Marvel-Schebler/Tillotson

SERVICE BULLETIN

#A1-81

SUBJECT: Model HA Carburetor Float Shaft and Bracket Wear

FIGURE 1

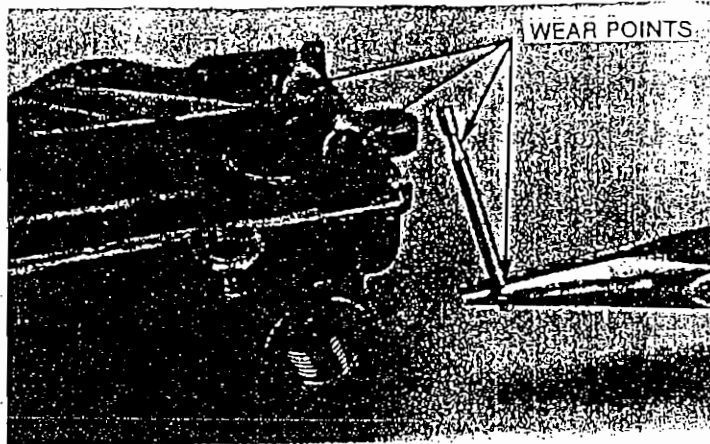
FIGURE 1 shows this wear condition which has been noted in some carburetors.

Use a #30 drill blank as a gage to check wear limits of both holes. If the #30 drill blank will enter either hole the wear limits are exceeded, a new casting is required.

If during inspection a worn casting is detected, a new cover must be used, as the worn float shaft hole will not accept the knurled float shaft press fit. A new cover can be ordered from your supplier from the following list which shows the HA Carburetor model number and the new cover assembly required.

FIGURE 2

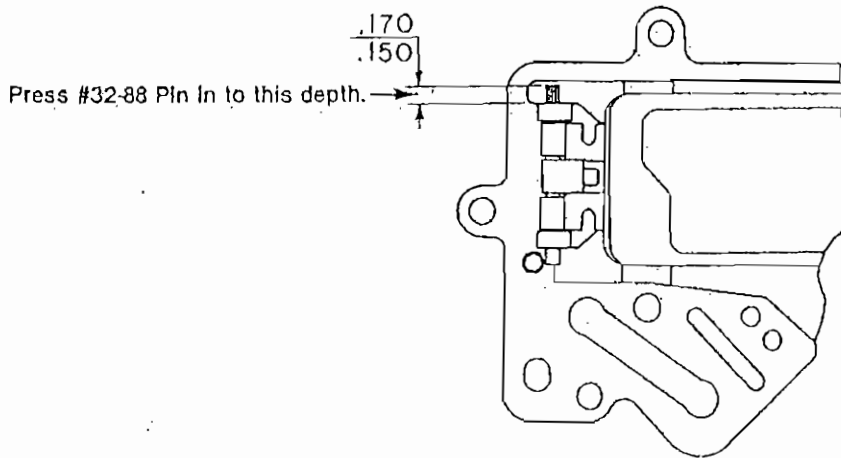
A kit can be obtained from your supplier to make the change to the new knurled pin. This kit is part number 666-824. It consists of the new knurled pin, the bowl cover gasket and 6 cover screw tab washers for re-safelying the carburetor.

After the installation of the new cover and pin, the carburetor is to be reassembled and safetied in accordance with manual procedures, a small "F" stamped on nameplate after serial number to show compliance, and a log book entry should be made.
